SITE INSPECTION SHEET

PROPOSAL: Retaining wall & shed

Site Inspection (6/13/16)
6535 River Clyde Drive
Highland, MD 20777

LOCATION DIAGRAM

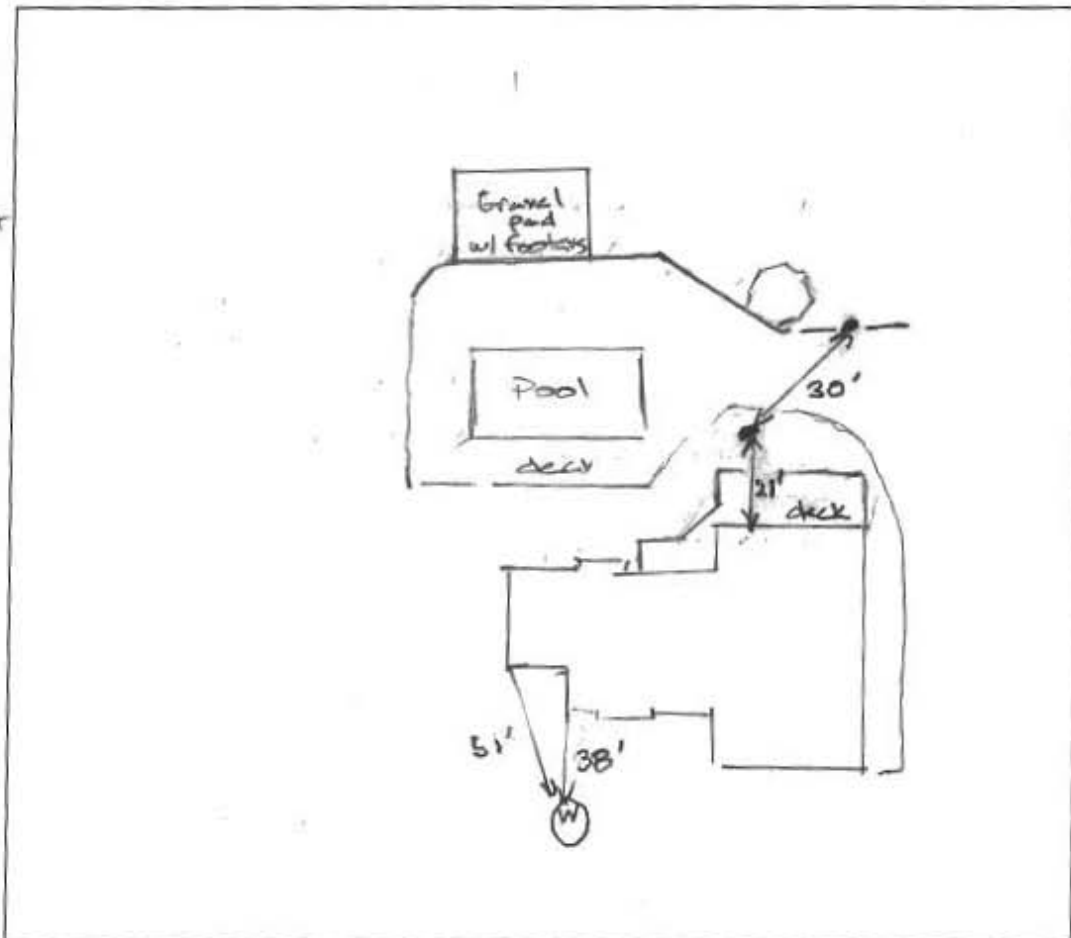
COMMENTS: Tank cleanout is 7'6" to the deck footer,
Well pvc conduit is not flush w/ cap. observed
an ant infestation inside conduit. No evidence
of sewage surfacing or odors.
